## Comparison Note for Thermal Discharges

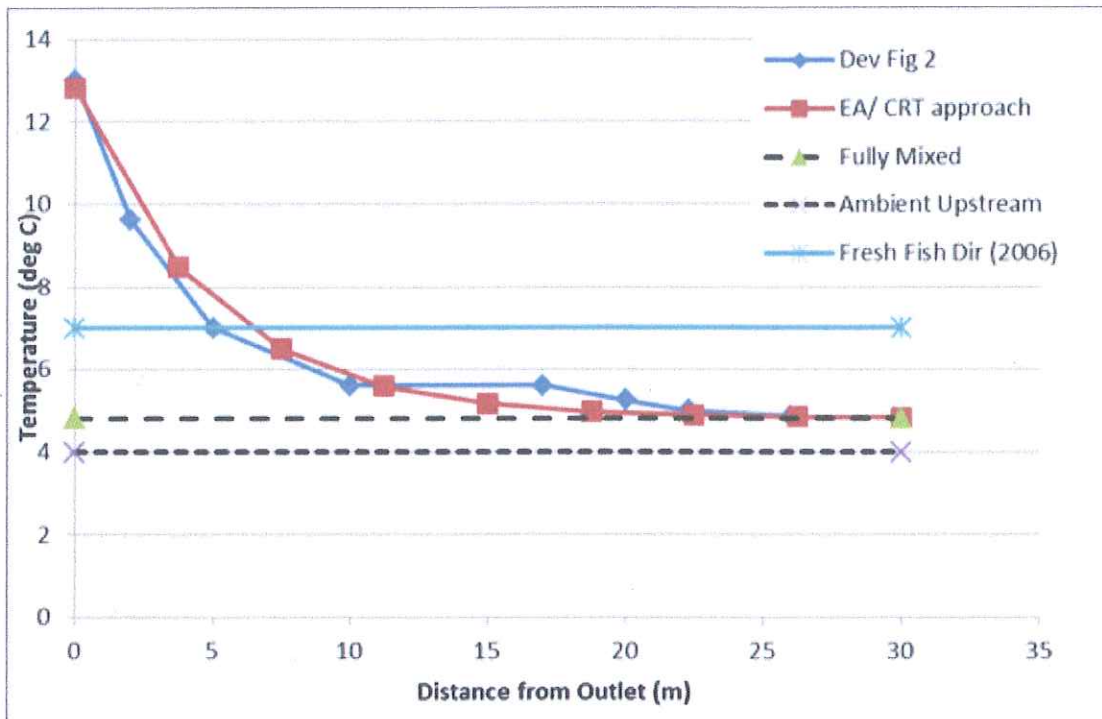
The applicant also presents results of the heat plume dilution for 1 winter scenario, this was produced by a CORMIX model (App 6.1). CRT ran this scenario through the agreed EA/ CRT methodology and the results are compared below:

The near field temperature results from the applicants analysis and the EA/ CRT approach are in close agreement. The illustration above also highlights the Freshwater Fisheries Directive (1996) temperature increase threshold for cyprinid water (which the Aire Canal is classified as). For this scenario it is clear that the majority of the canal width would be below the permissible temperature increase of 3 deg C, beyond a distance of about 5m from the outlet. Other scenarios were tested by CRT using the EA/ CRT approach and are given CRT (2014: Appendix C). These results similarly demonstrate that the plume dispersion allows ample space for fish to pass the discharge point. We conclude that the results for within the mixing zone are also consistent between the Applicant's and CRT's analysis. The key differences appear to be in the interpretation of the results in terms of the potential environment impacts. CRT maintain that their results demonstrate that the discharge to the canal would comply with the requirements of the Freshwater Fish Directive (1996).
